Service Bulletin

Bulletin No.: 23-NA-137

Subject: Information on Transmission Case Flange Interference

Brand:	Model:	Model Year:		VIN:		Engine:	Transmission:
		from	to	from	to		
Cadillac	CT6	2016	2020	—	—	—	8-Speed Automatic (RPOs M5N, M5X)

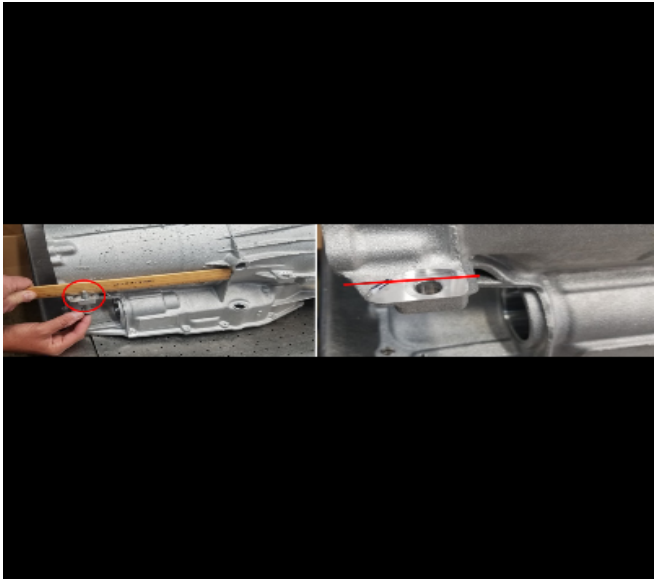
Involved Region or Country	North America
Condition	 <p style="text-align: right; font-size: small;">6403157</p> <p>Some technicians may find it difficult to install the front propeller shaft due to contact with a flange located on the transmission case.</p>
Cause	This condition may be caused by a transmission case used on multiple vehicle platforms that require this flange to support a heat shield.

<p>Correction</p>	<div style="text-align: right; margin-bottom: 10px;">6403175</div>  <p>Note: Graphic depicts transmission removed from vehicle for clarity.</p> <p>The technician will need to remove the flange by cutting it off with one of the identified cutting tools:</p> <ol style="list-style-type: none"> 1. Utilizing a straight edge or equivalent, mark a straight line across the flange as shown in the graphic above. 2. Utilizing a cutoff tool or equivalent, cut along the line.
--------------------------	--
